Camden Town Hall Annexe

Planning Amendments

Crosstree Real Estate Partners LLP

September 2015

Proposed scheme goods lift extended - Whidborne street

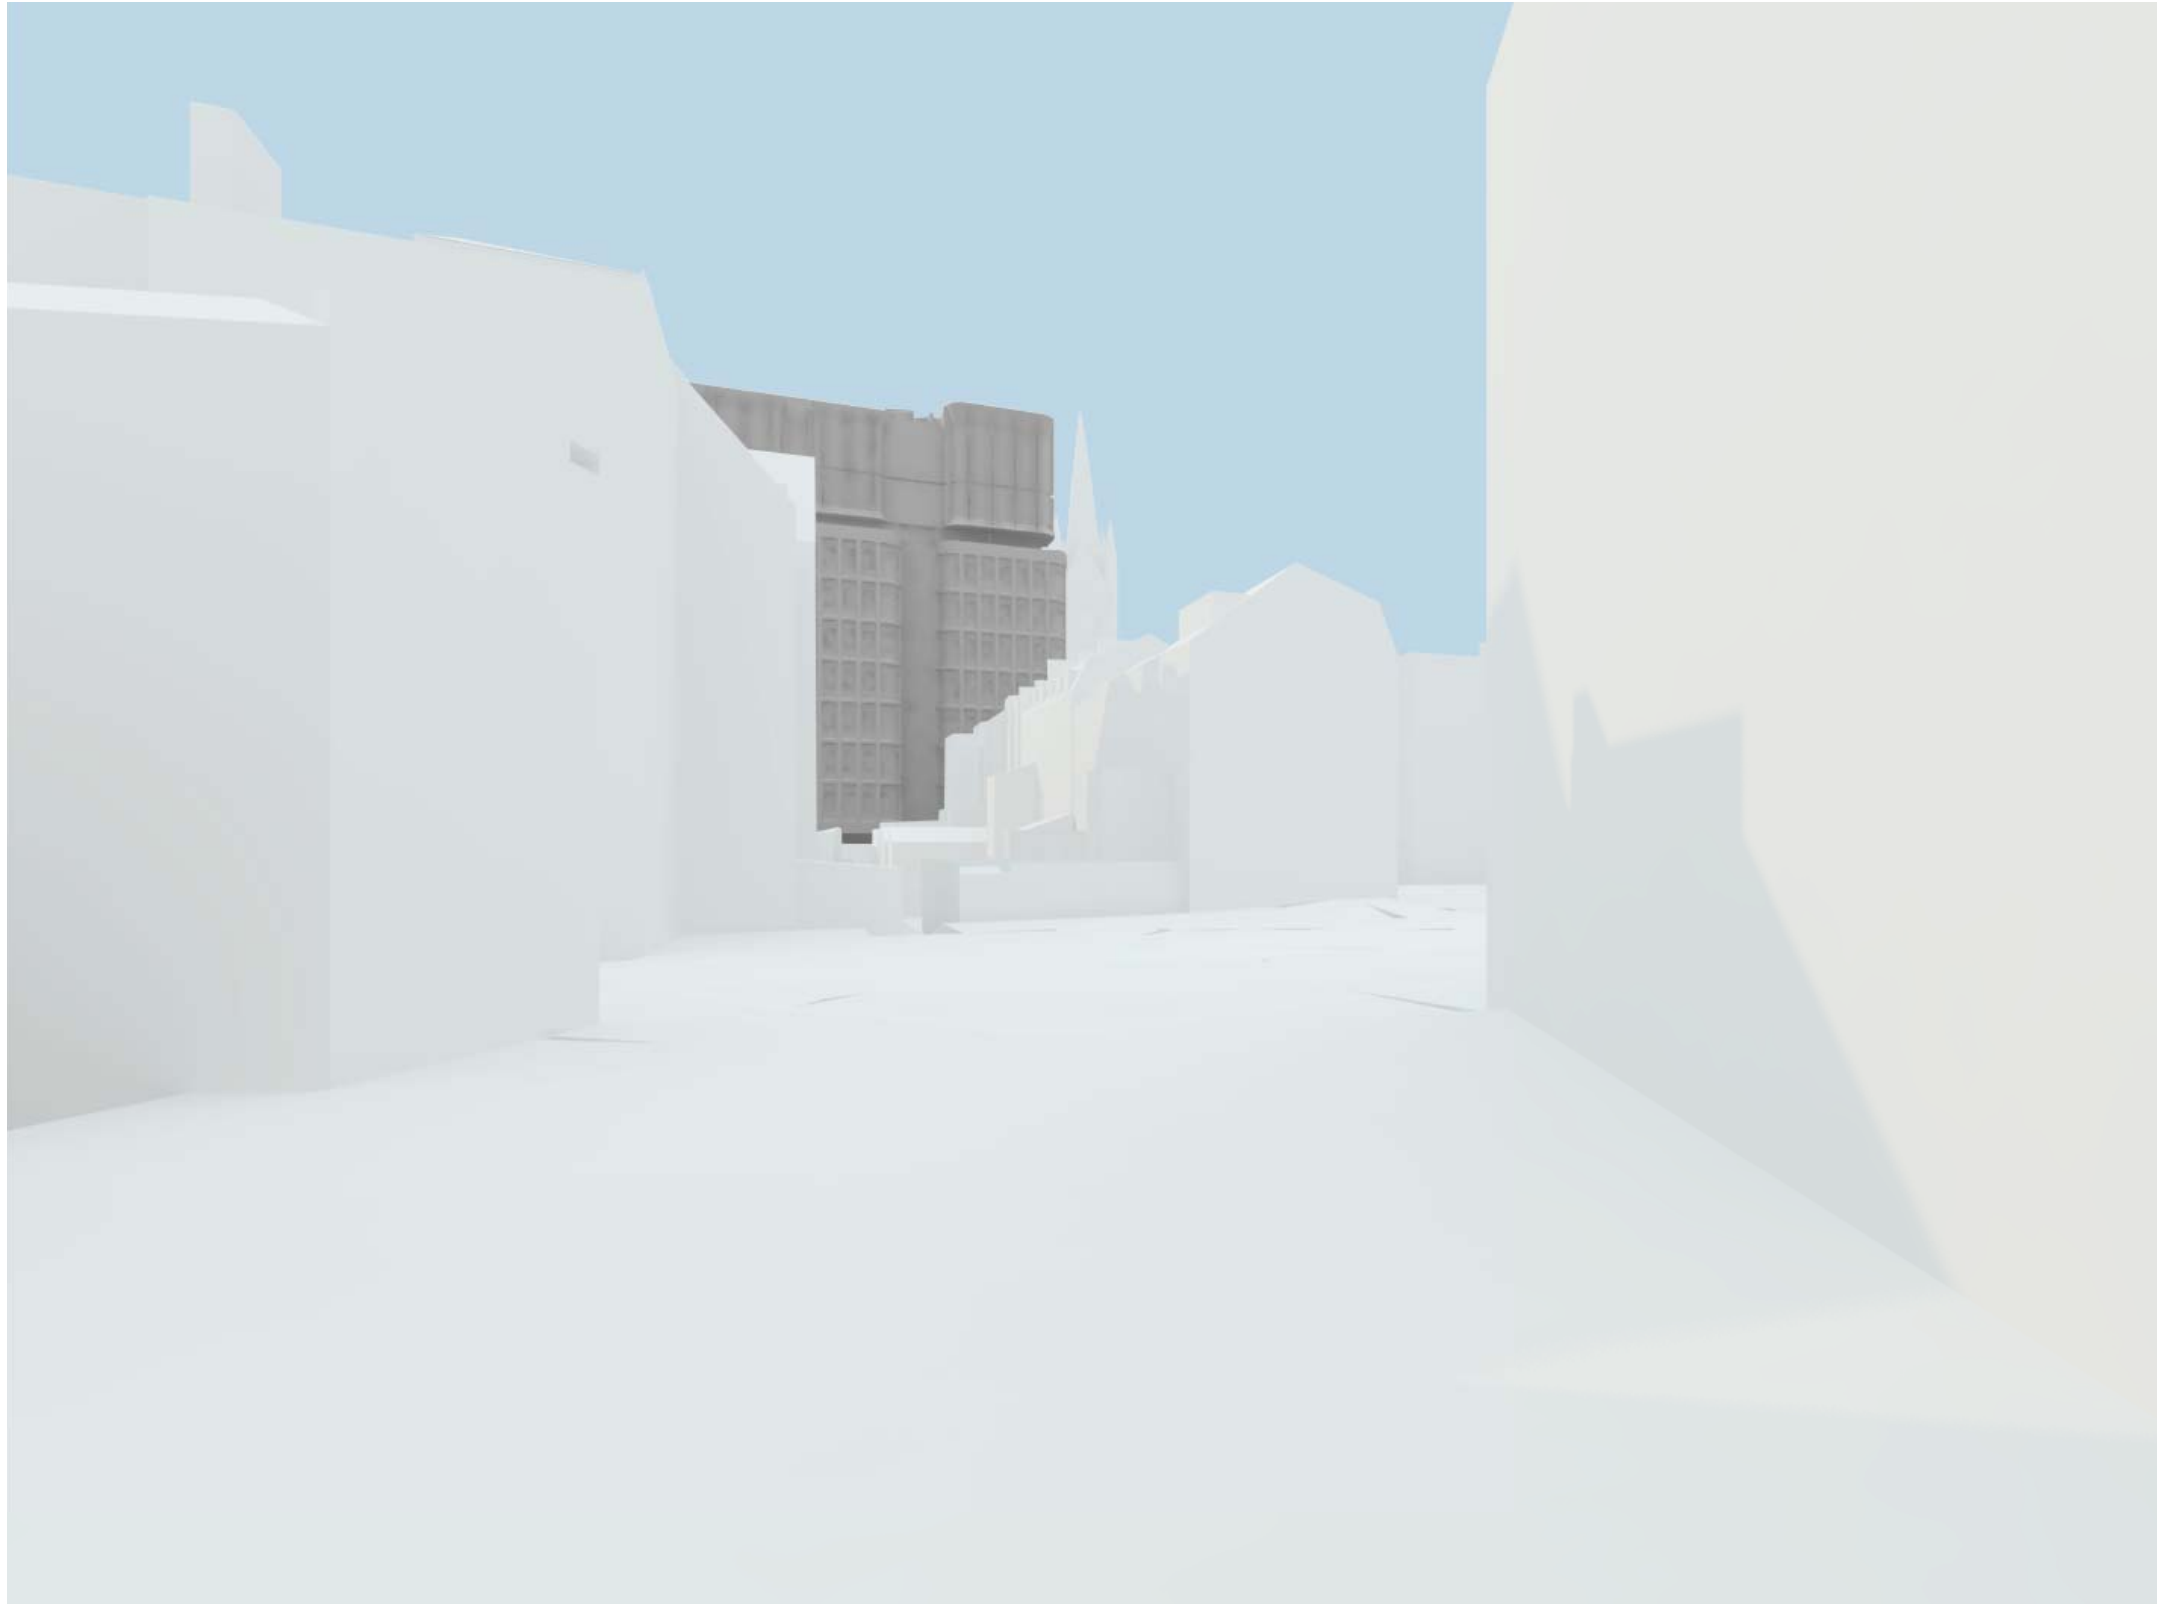
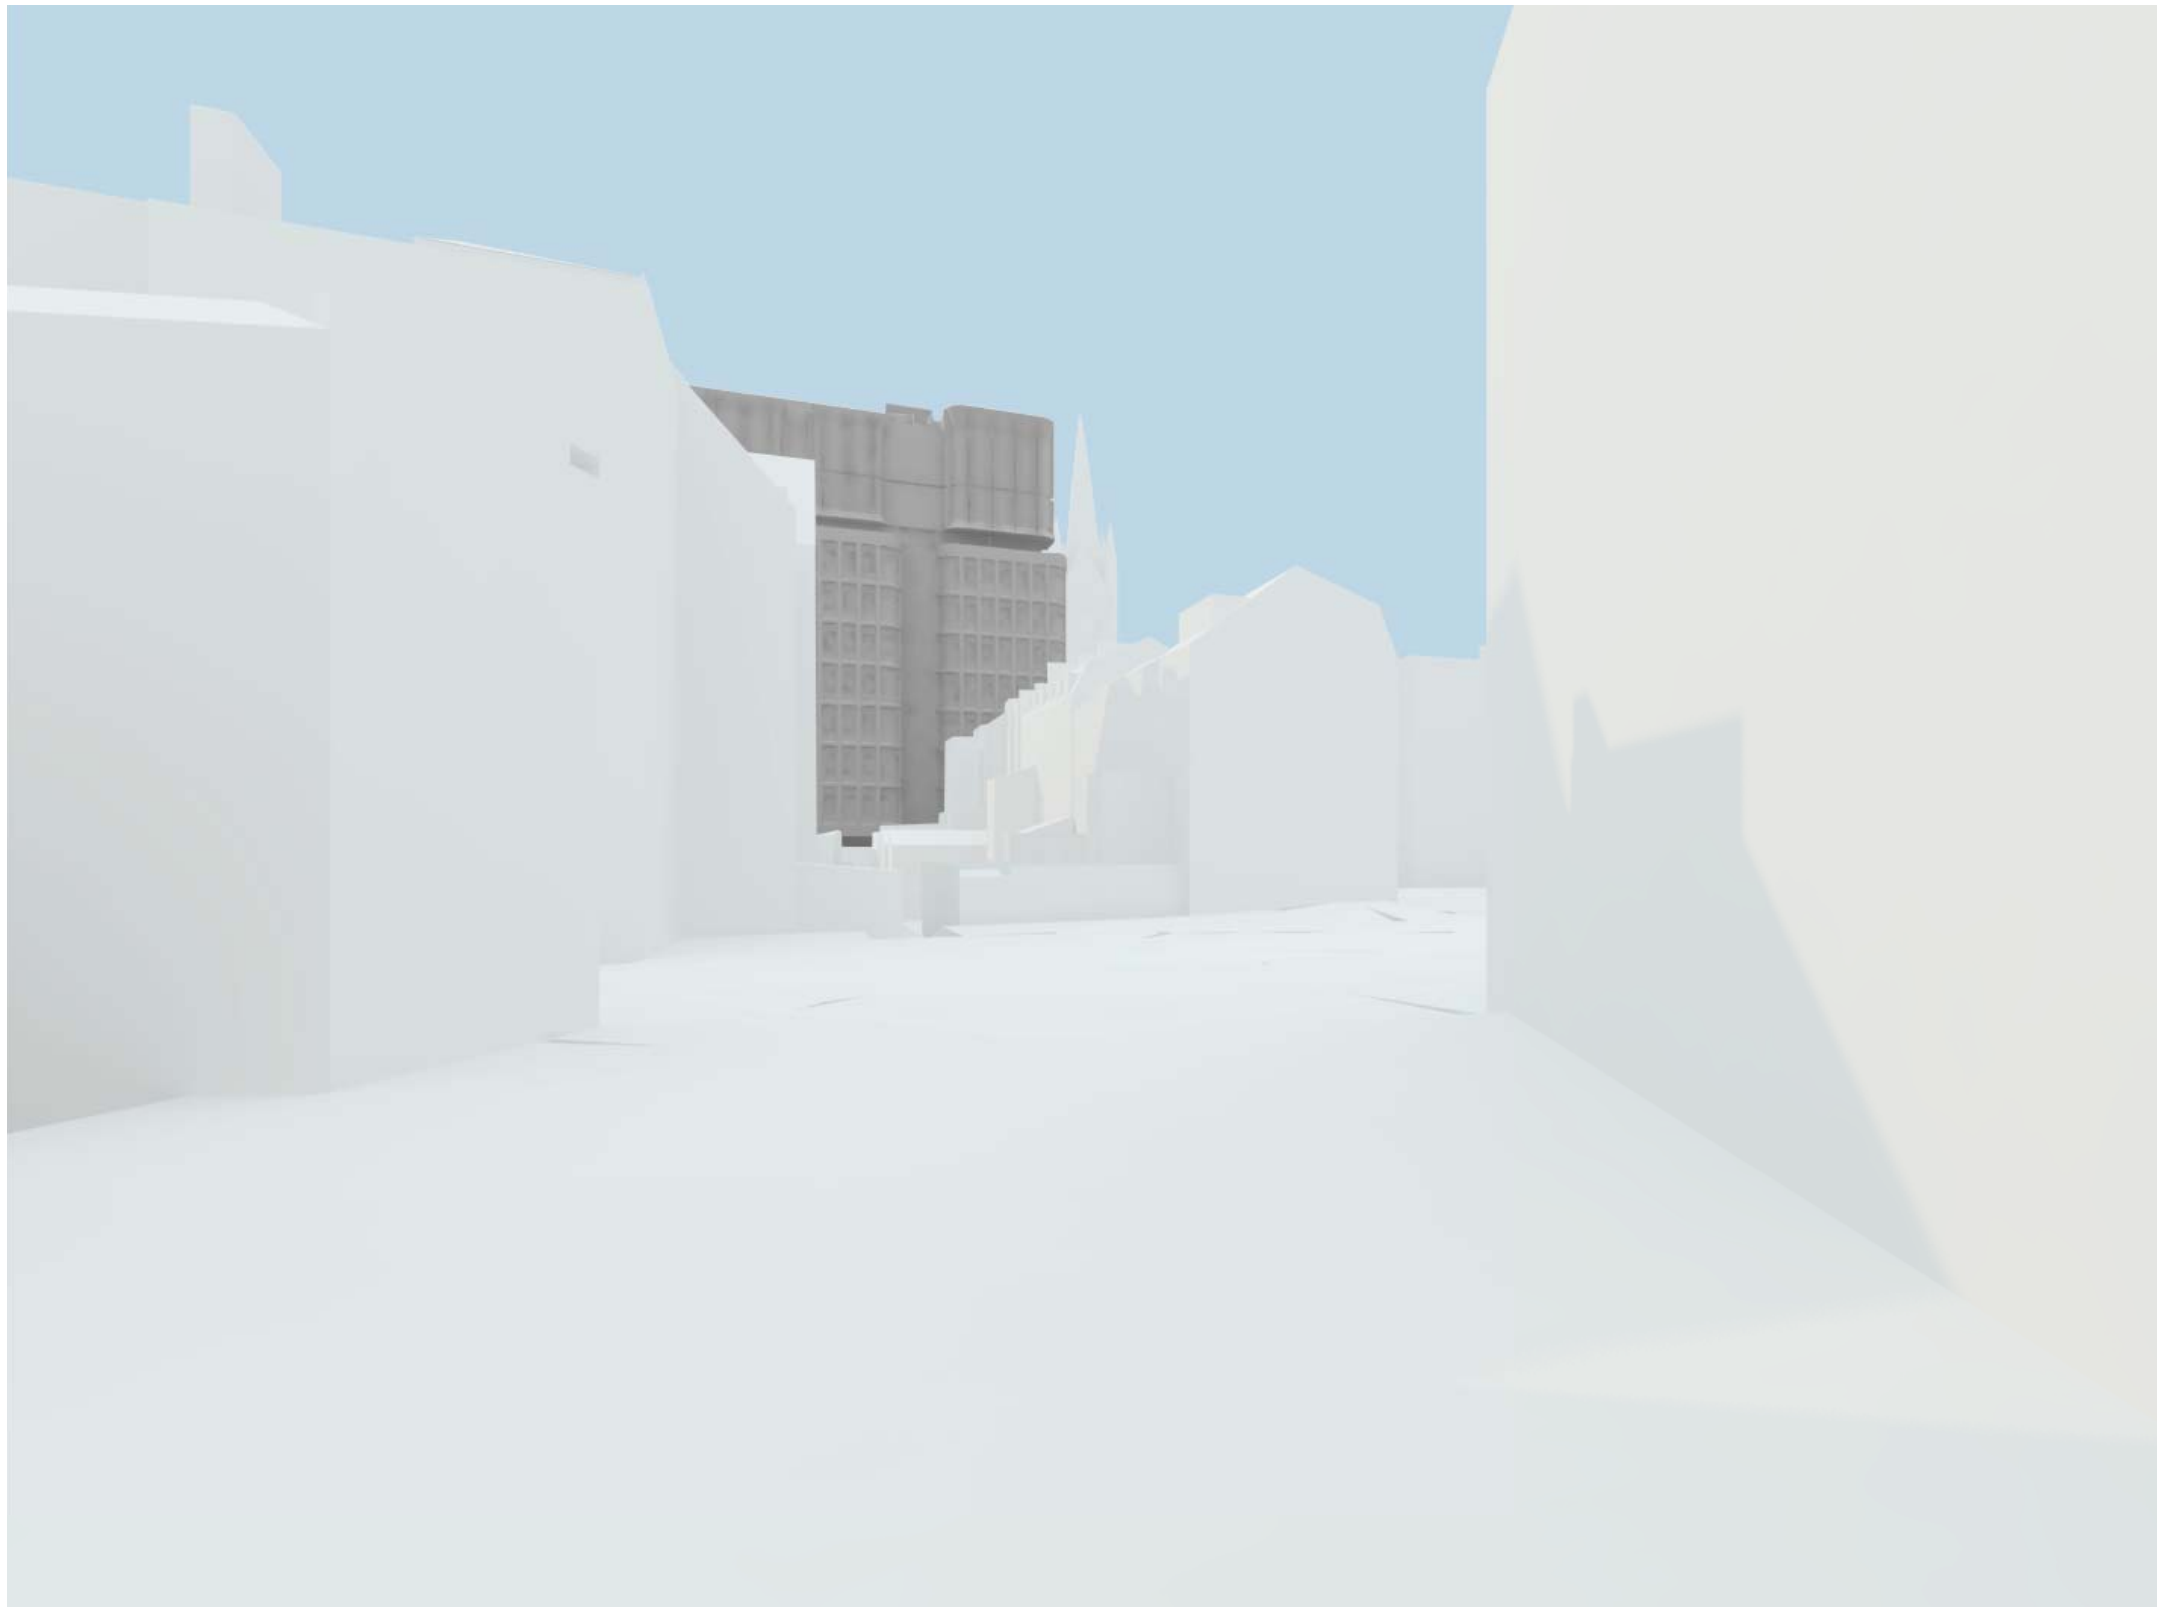
Top of goods lift 5505mm from roof FFL
